UNITED STATES  
NUCLEAR REGULATORY COMMISSION  
WASHINGTON, D.C. 20555-0001

December 1, 1995

APPLICANT: Westinghouse Electric Corporation  
PROJECT: AP600  
SUBJECT: SUMMARY OF MEETING TO DISCUSS THE USE OF MAAP4 FOR AP600  
PROBABILISTIC RISK ASSESSMENT (PRA) SUCCESS CRITERIA ANALYSIS

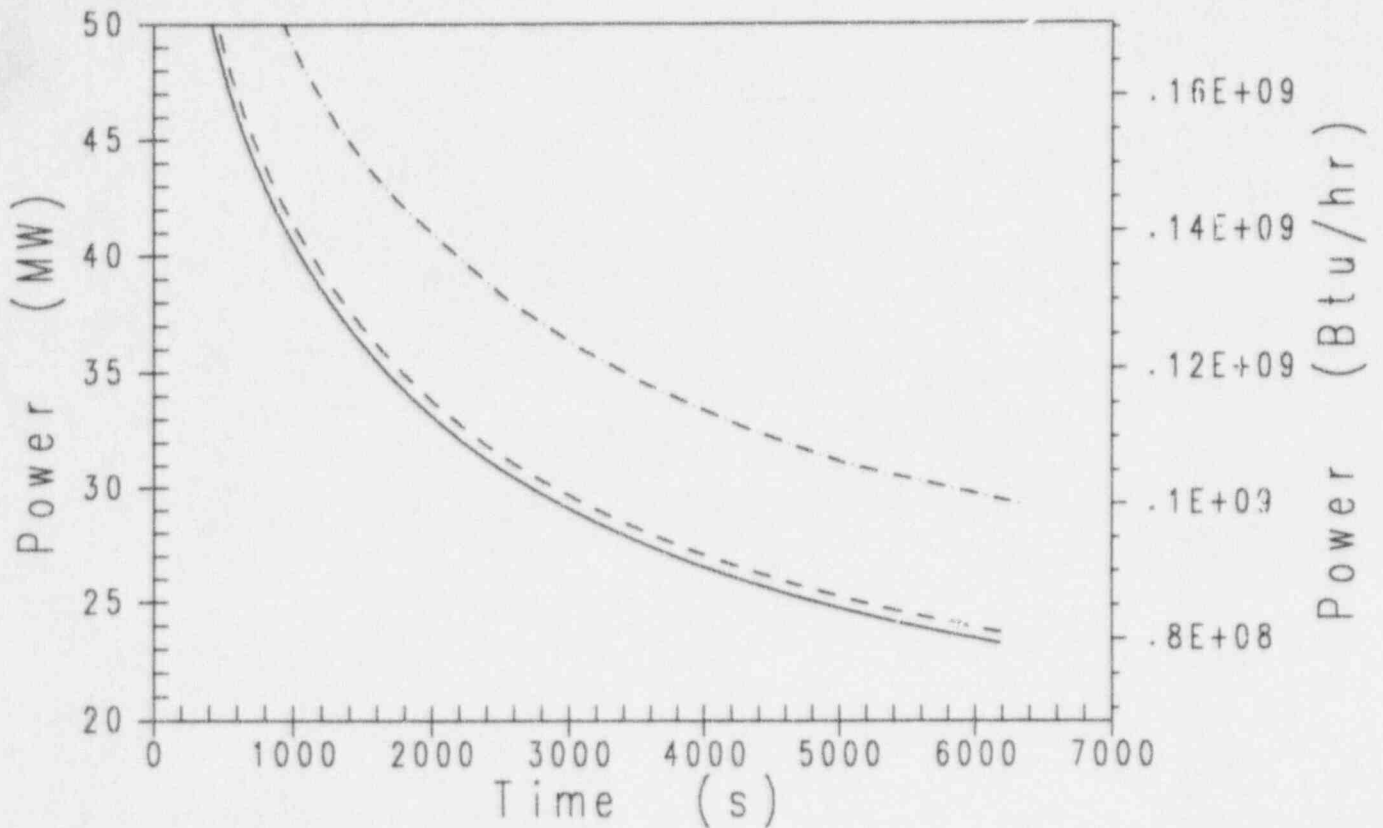
It was noted that the peak cladding temperature (PCT) calculation does not represent the hot pin PCT. This is because the lumped radial peaking factors used in the MAAP4 core noding do not model the hot pin radial peaking factor. Therefore, the MAAP4 calculated PCT margin to the 2200°F criterion for various success sequences is not as large as it appears to be.

## ACCUMULATOR SENSITIVITY CASES

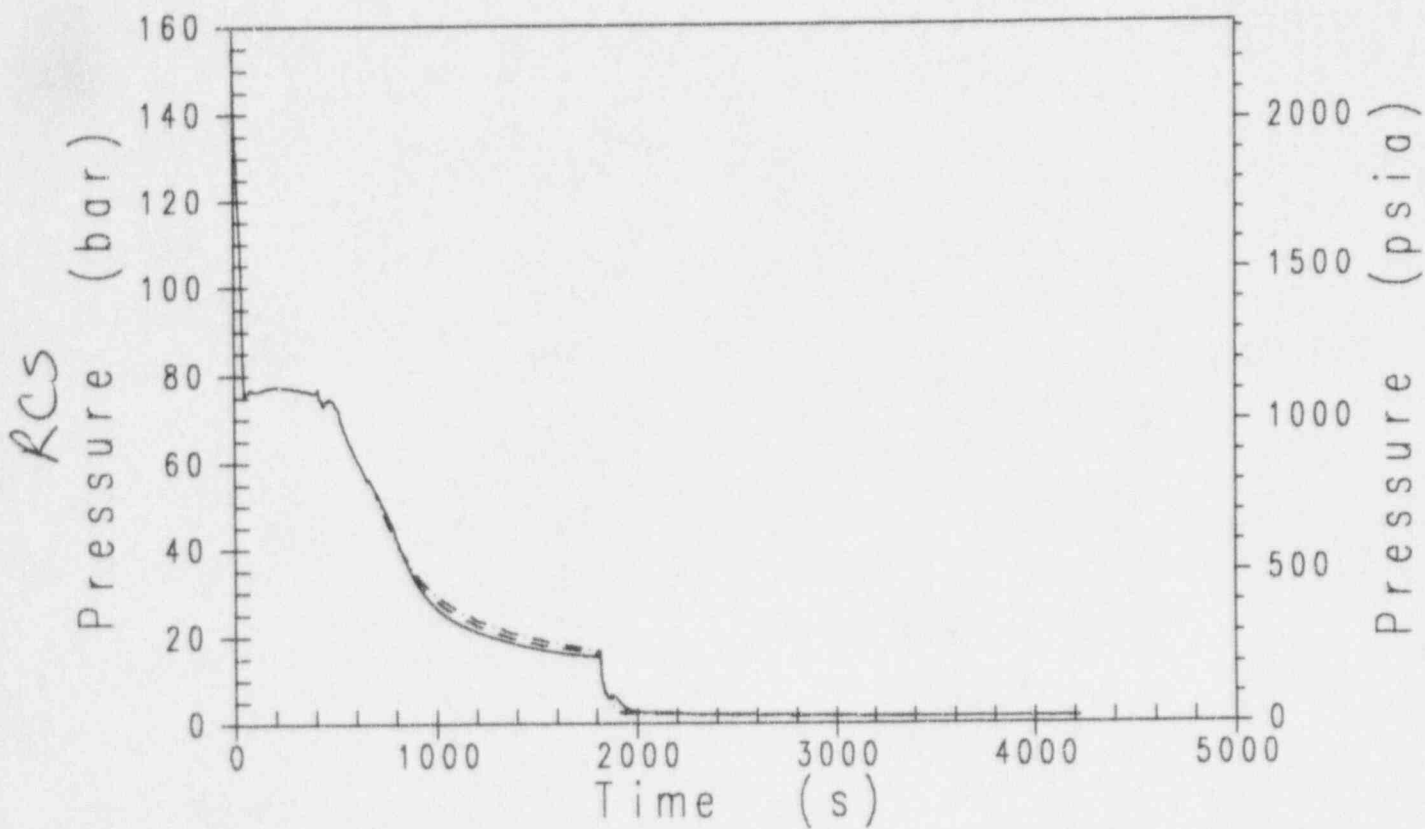
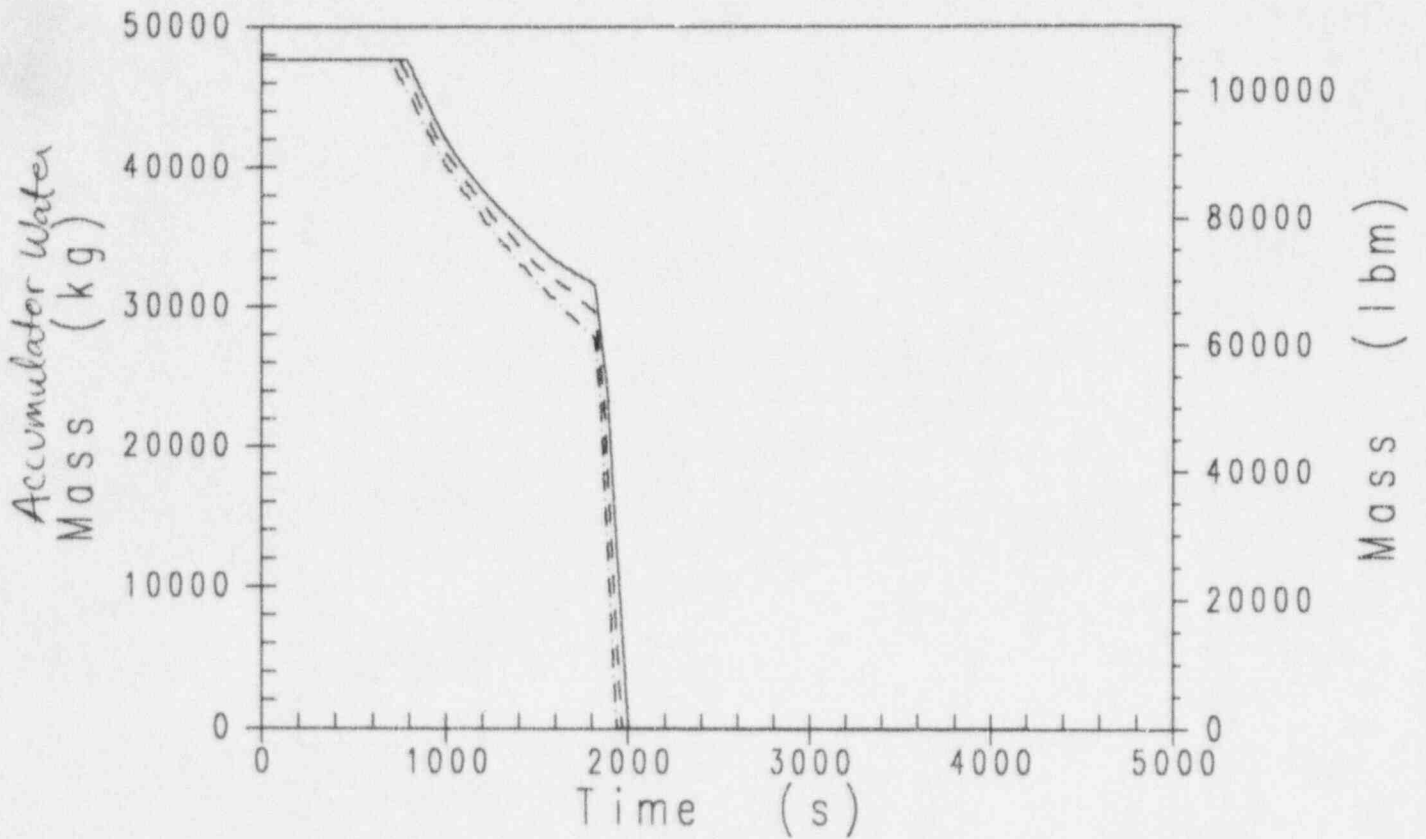
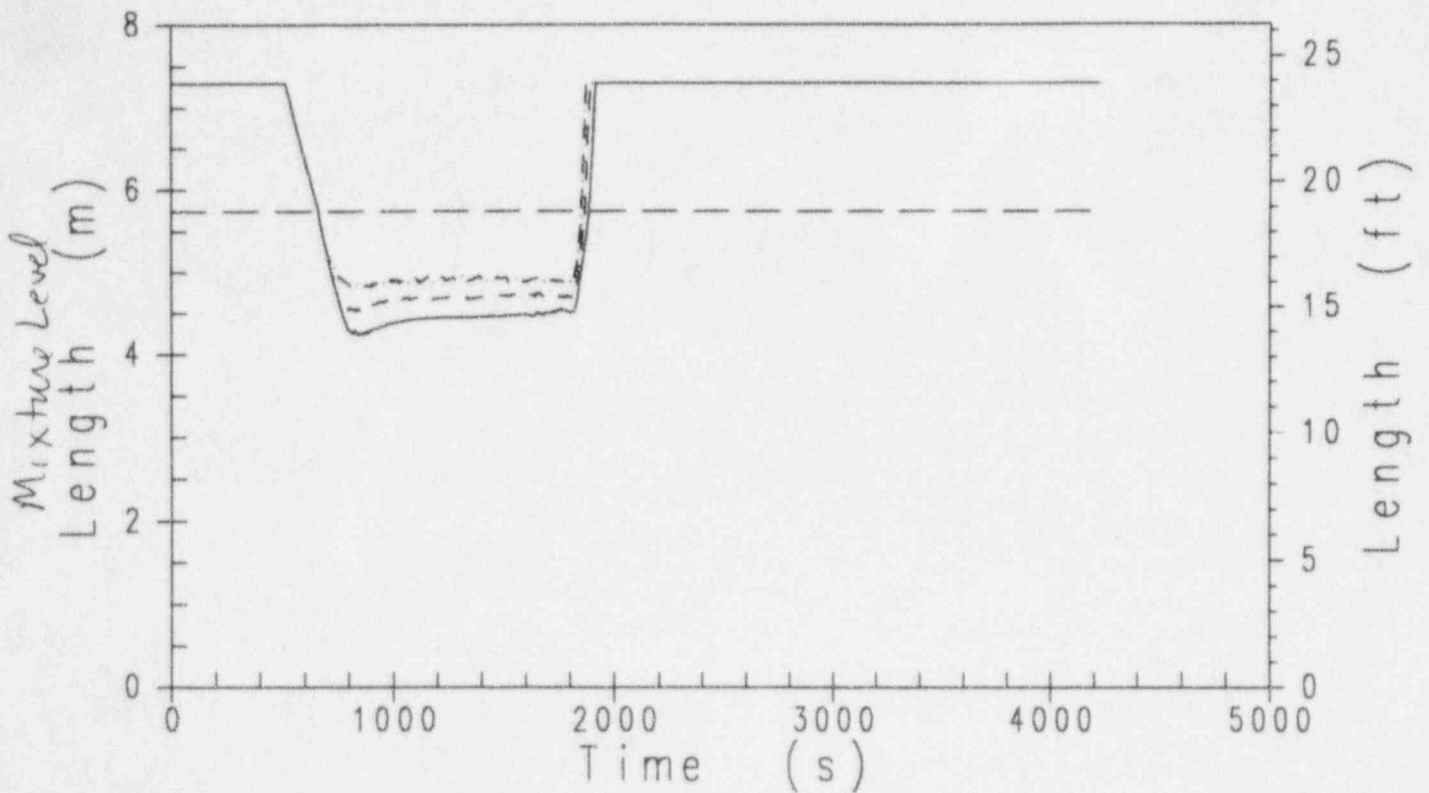
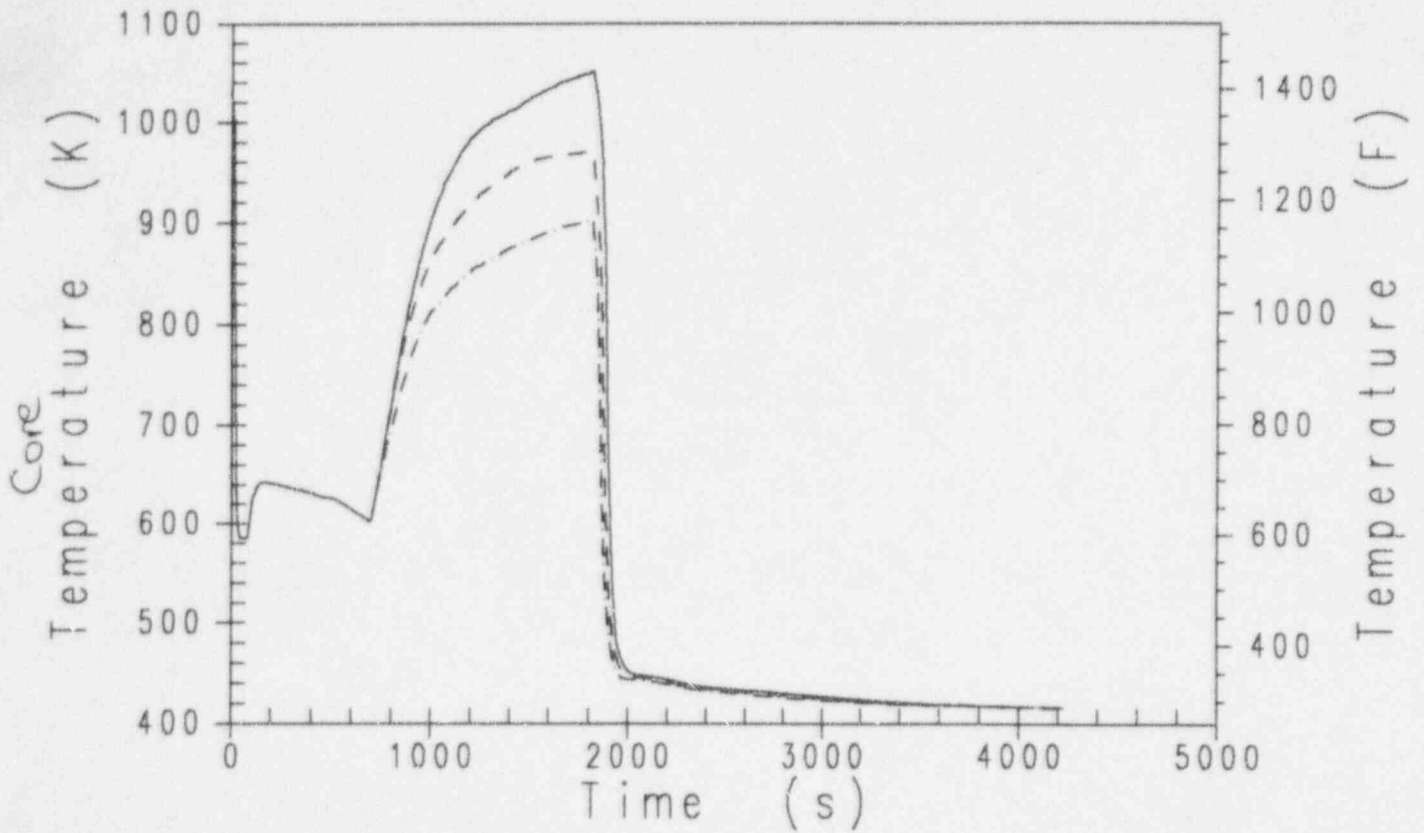
The accumulator modelling assumes an isothermal expansion of the gas in the accumulator to calculate pressure. The staff requested that Westinghouse examine the impact of an adiabatic expansion of accumulator gases and how MAAP4 results are affected.
